**Re: Site Review Permit Application
Proposed Multifamily Development, 2454 Lafayette Road, Portsmouth, NH**

PROPOSED MULTI-FAMILY DEVELOPMENT PORTSMOUTH GREEN

City of Portsmouth TAC, November 2, 2021:			
	TAC Comment	Applicant Response	Sheet
TAC Comments from 11/1 Correspondence:			
1	The City requests a multi-use path on Constitution from back entrance of development to Banfield Road.	The applicant has agreed to design and construct a multi-use path on Constitution Ave from back entrance of development to 199 Constitution Ave as part of this project. The applicant has also agreed to prepare, and provide to the City, design plans for the remainder of the multi-use path from 199 Constitution Ave to Banfield Road subsequent to Planning Board approval.	C-201, C-202 & C-203
2	The dog park should include a detail showing the interior gates, surface material and drainage system.	Additional details have been added to the dog park showing the interior gates, surface material, and detailed grading.	C-102.1, C-103 & L-100
3	Given the location, the pickle-ball courts should include night court lighting.	Dedicated light for the pickleball courts has been added to the photometrics plan.	C-10

C-102.1

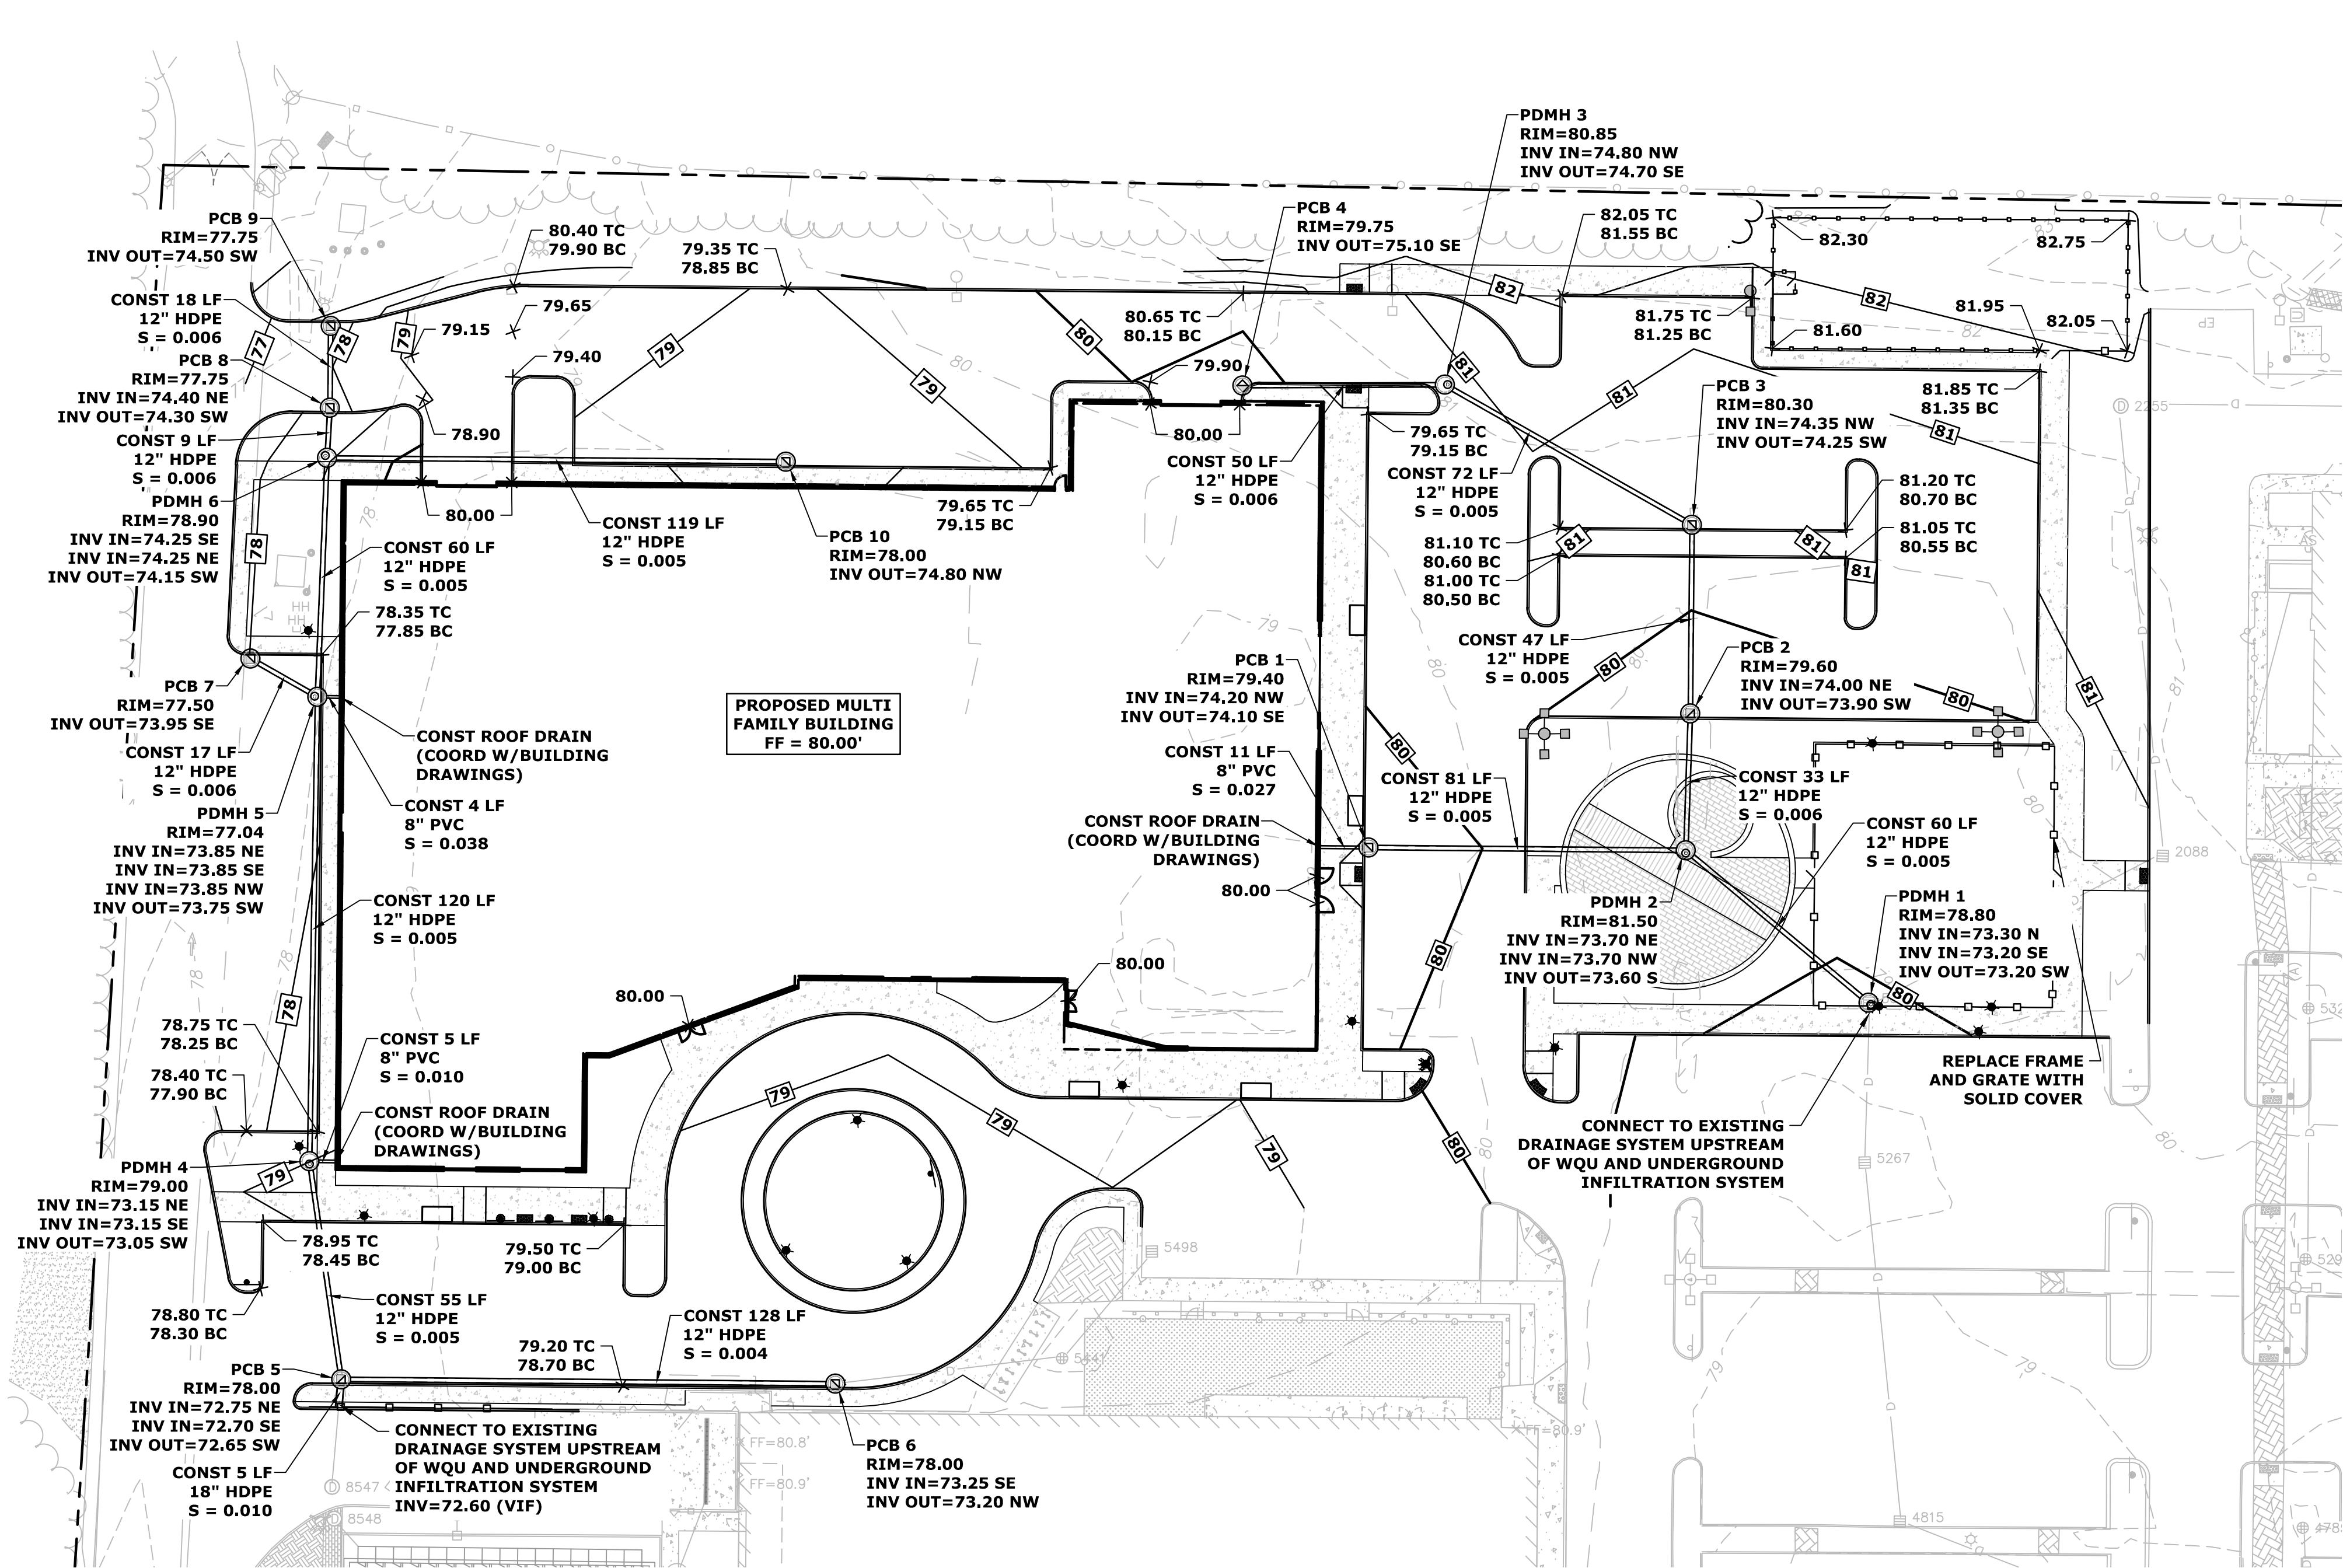
4	The roundabout details should match the lines and dimensions shown on the site plan.	Additional dimensions have been added to the site plan to clarify the dimensions of the roundabout and to conform with the detail.	C-102.1
5	The side entrance to the proposed bicycle center should be modified to be a stronger design element thereby activating this elevation as a primary façade of the building.	The side entrance to the proposed bicycle center has been revised to further activate the façade of the building.	Building Renderings
6	The proposed community spaces should be shown on a plan. Please provide a matrix showing type, area, and location.	The Community Space Exhibit has been revised to include separate community space types and square footages of each type.	Community Space Exhibit
7	The proposed workforce housing units should be identified (using a table and note) on the plan by the location, size, and number of bedrooms.	The proposed workforce housing units have been identified on the plan by the location, size, and number of bedrooms.	A-602, A-603 & A-604
